**STAFF REPORT: MAY 10, 2023 REGULAR MEETING**

**APPLICATION NUMBER: 23-8336**

**ADDRESS: 1453 W BOSTON**

**SCOPE: REPLACE SLATE ROOF WITH ASPHALT SHINGLE ROOF, REHABILITATE AND EXPAND DRIVEWAY AND PATIO, REMOVE TREE**

Left: Existing roof. Right: Proposed replacement product. Image from submitted application materials.

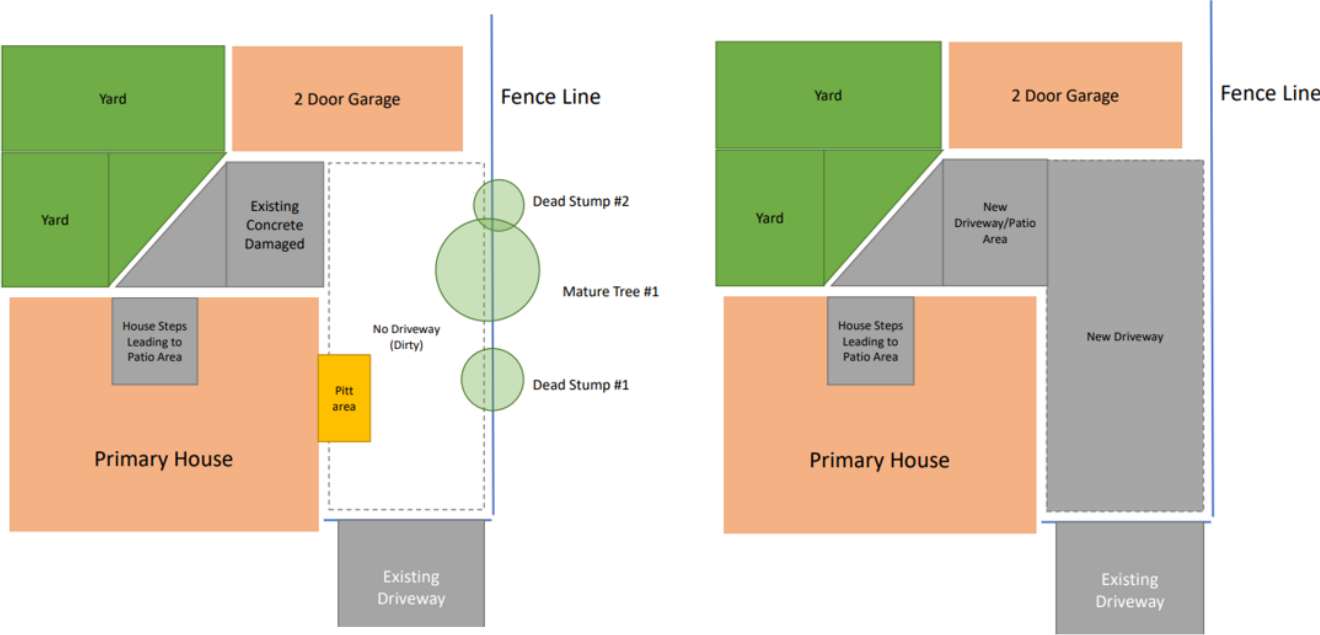
- A slate roof is almost invariably a distinctive, character-defining feature of a building, as is the case with the house and garage on this property. The slate roof appears to be original to the house and garage.

- The deterioration on the garage roof is clearly more severe than on the house, with missing tiles on all planes and visible damage to the decking below.

- The documentation submitted by the applicant is comparable to that of several other proposals the Historic District Commission has issued a Certificate of Appropriateness for within the past three years. The argument provided by the applicant is based on a statement from an experienced contractor advising against repair and providing amounts for two replacement alternatives. This implies a financial feasibility argument as described in the previous bullet point.

Staff recommends that the Commission issue a Certificate of Appropriateness for the proposed work as it meets the Secretary of the Interior’s Standards for Rehabilitation, with the following conditions:
